Author's Responses to comments on "Ensemble numerical simulation of permafrost over the Tibetan Plateau from Flexible Permafrost Model: 1950–2023"

Wen Sun and Bin Cao

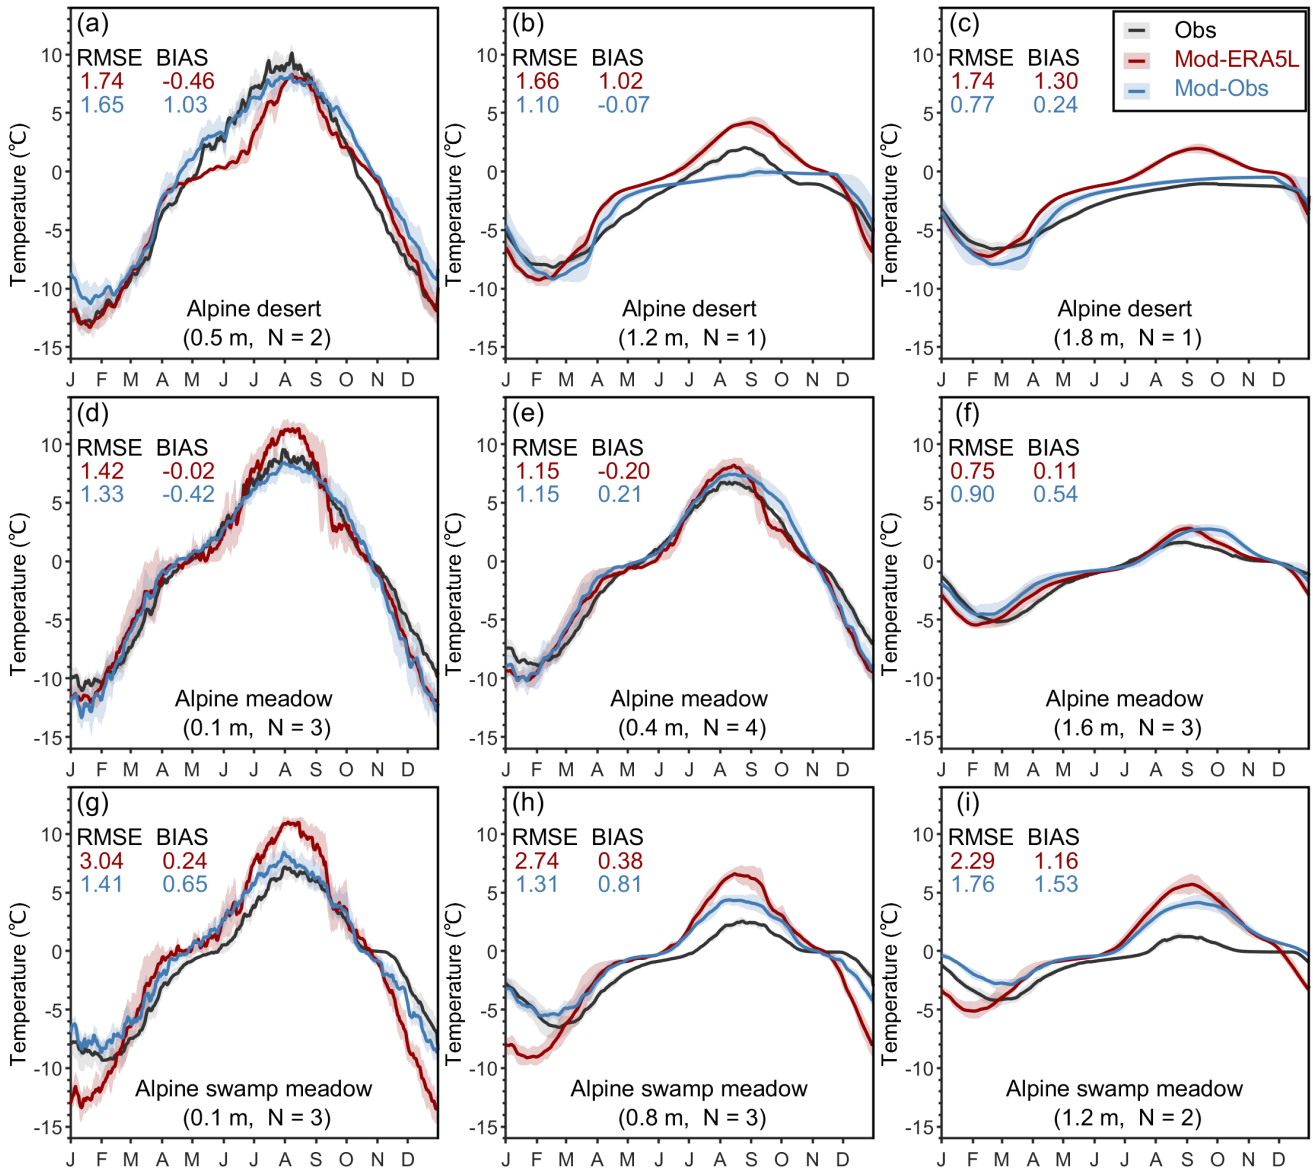
6. Figure 2: I was wondering why the legend in this figure states "Mod-Obs" if the black line represents the observational soil temperature. Please clarify what the black line represents and ensure the legend matches the plotted quantity.

Response: The legend should be revised: black line is observation (OBS), red line is simulations forced by ERA5-Land (MOD-ERA5L), and blue line is simulations forced by measured soil info (MOD-Obs) revised as below.

Figure 5: Same as Figure 3, but for the changes of mean annual ground temperature (MAGT) at 15 m depth. Only the sites with long-term observations (≥ 1 decade) are used here. The filled dots are sites with observed significant trends. Dashed lines indicate ± 0.1 $^{\circ}\text{C dec}^{-1}$.

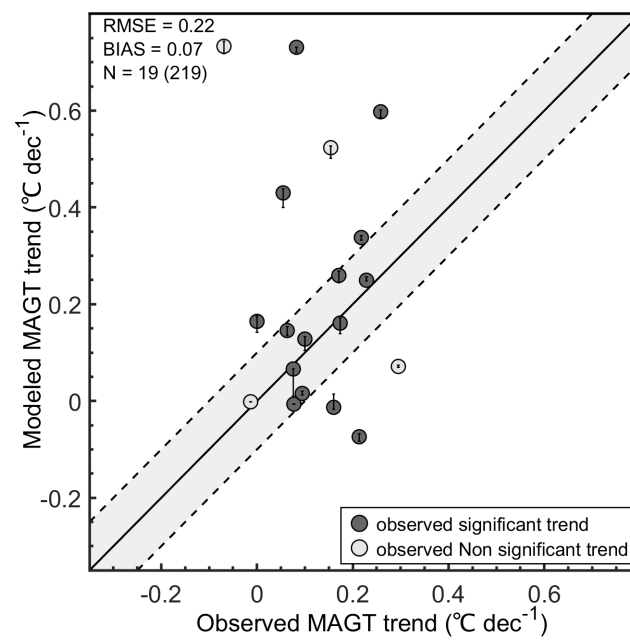
8. Figure 5: What does "0.33 (0.07)" indicate in the text in the figure?

Figure 4 and 5 : at what depth? (state it in the caption)

Response: The RMSE = 0.33 and the BIAS = 0.07, the figure was revised as below. Note that numbers were updated as we conducted the simulations using variable air density.

Response: at 15 m depth. In the caption, we revised as below to clarify.

Figure 5: *"Same as Figure 3, but for the changes of mean annual ground temperature (MAGT) at 15 m depth."*

Figure 8: Changes of permafrost extent, as permafrost zonation index (PZI), between 2010–2023 and 1981–1990. The PZI is 45-member ensemble probability of permafrost where permafrost is defined by the daily temperature at 15 m depth, and negative values indicate a loss in permafrost extent.

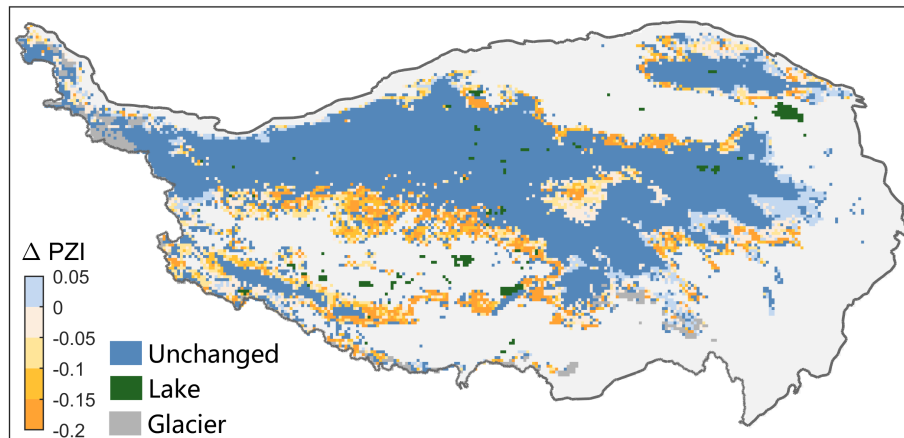
Figure 8 : I do not understand this figure : dark orange is 0.2, does it means that 20% of the permafrost in the pixel is lost? Or that there is a 0.2 probability to find permafrost in the pixel at the end of the simulation? The caption needs to be clearer.
Response: It is the Δ PZI (see the legend). We agree the figure is unclear and even misleading. This is because a loss of permafrost should be given as negative value. We reformulated the figure and the caption was changed as above to clarify.
